Re: Final Plat S/D 87-9 - HILLSIDE GARDENS 2ND ADDITION

At the regular meeting of the Subdivision Committee of the Metropolitan Area Planning Commission on Thursday, February 12, 1987, the above-captioned plat was considered. The action of the Committee was to recommend that this plat be approved subject to:

Final Plat
SUBDIVISION REPORT

Name: HILLSIDE GARDENS 2ND ADDITION

OFFICE COPY
DO NOT REMOVE
FINAL PLAT

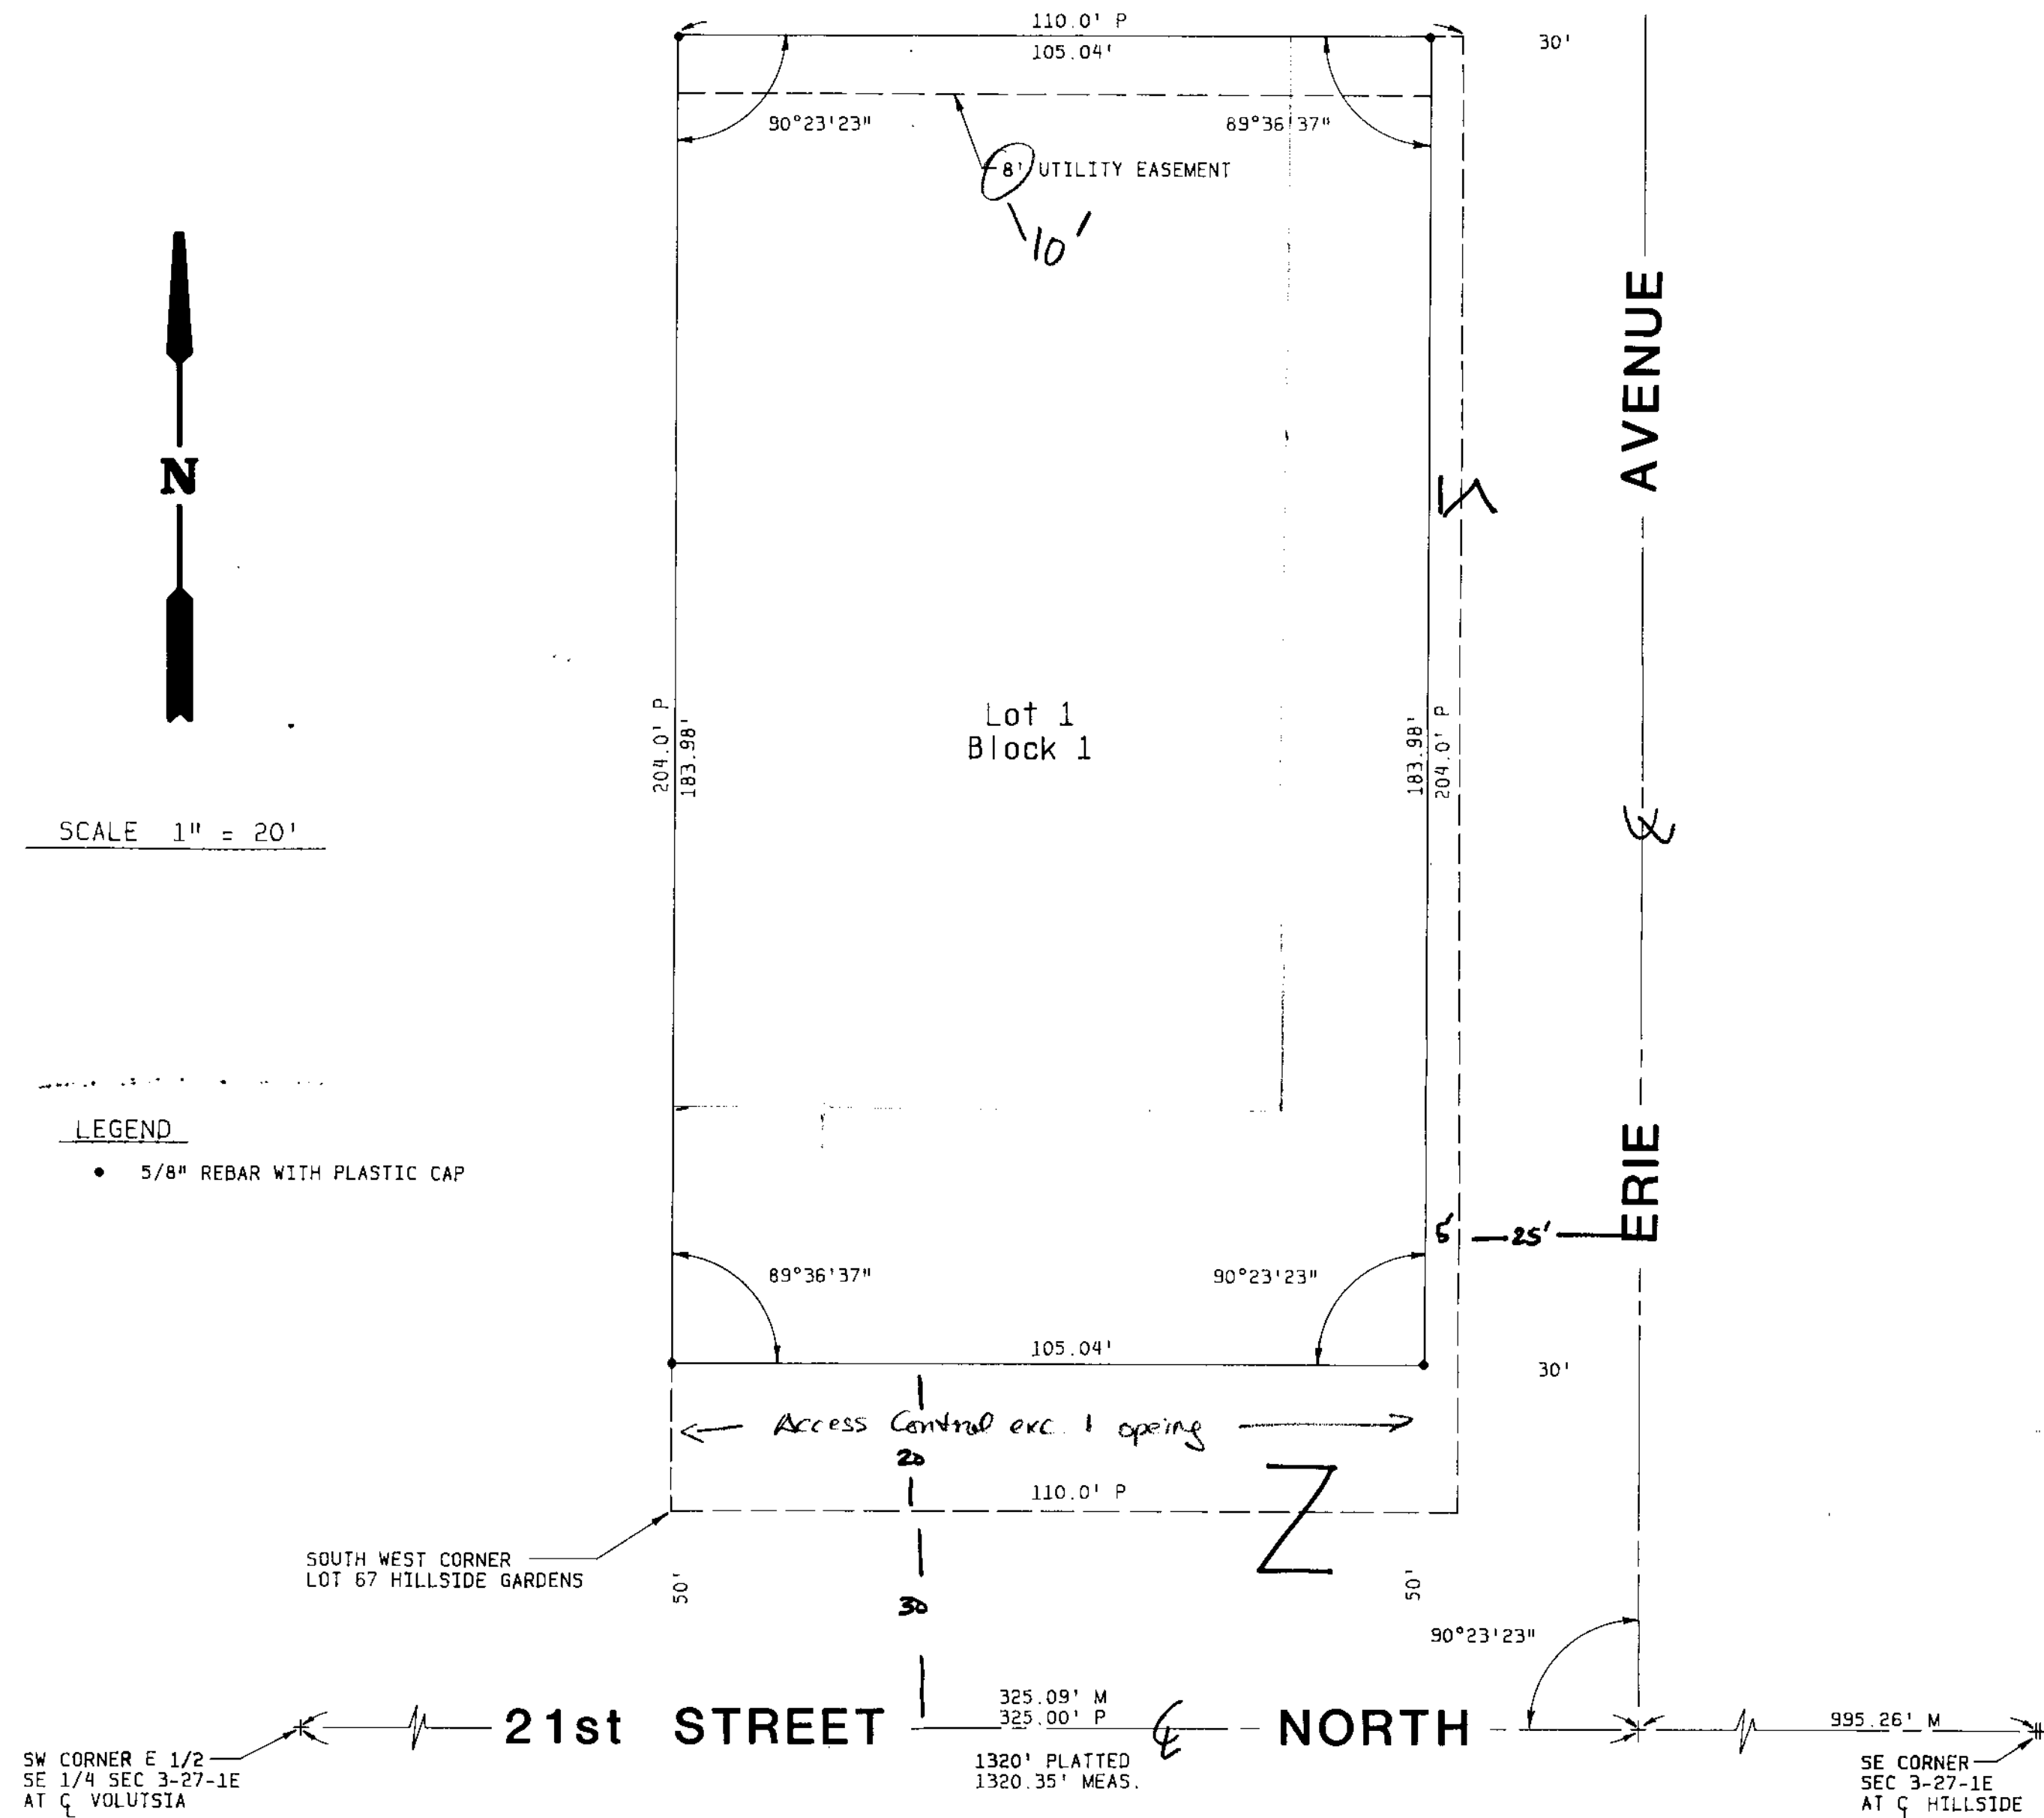
- ~~G.~~ The applicant's engineer is advised that the Register of Deeds is requiring the name(s) of the notary public, who acknowledges the signatures on this plat, to be printed beneath the notary's signature.
- ~~H.~~ The applicant shall install or guarantee the installation of all utilities and facilities which are applicable and described in Article 8 of the MAPC Subdivision Regulations.
- ~~I.~~ Perimeter closure computations shall be submitted with the final plat tracing. Section 5-101(C).
- ~~J.~~ Recording of the plat within 30 days after approval by the Board of City Commissioners.

- Needs*
- A. The final plat tracing shall indicate the platting of "access control except for one opening" to 21st Street North across the south line of this lot. The platting of this access control shall be referenced in the platlor's text. *Need to add phrase about permit to be determined by the City Engineer.*

- ~~B.~~ The final plat shall indicate the amounts of half-street rights-of-way adjacent to the plat as well as the amount of additional rights-of-way being dedicated by this plat.

- ~~C.~~ The final plat tracing shall label the centerlines of the adjacent perimeter streets.
 - ~~D.~~ The final plat shall indicate a 10-foot utility easement adjacent to the north line of Lot 1, Block 1.

- ~~E.~~ Since an existing sidewalk system does not exist to the north, it is recommended that the sidewalk required on Erie, by this lot's commercial zoning, be waived.

- ~~F.~~ The final plat tracing shall indicate a 35-foot building setback from 21st Street North and a 20-foot wide building setback from Erie Avenue. Section 28.04.188.8 of the City's Zoning Ordinance provides for the construction of detached canopies within building setbacks.
